BLM SCALAR FIX -Based on findbhudda's original design:

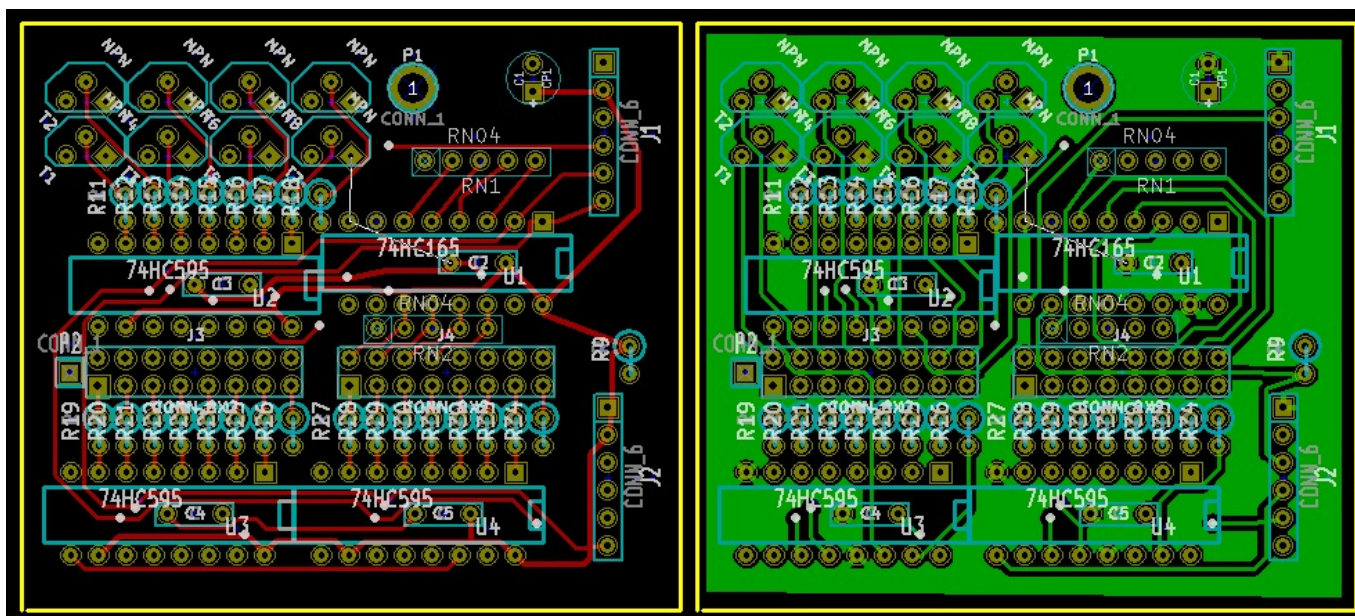
- blm-scalar.* contain an error. Pins I4-I7 are mirrored. This is easily fixed with a connector modification, and the blm-scalar module seems to work as intended.
- blm-scalar v1.1 attempts to fix this error. Moved connectors J1, J2, Resistor Net 1 and R9 to make room for corrections.

Corrected blm-scalar v1.1.brd [blm-scalar_v1.1.brd.zip](#)
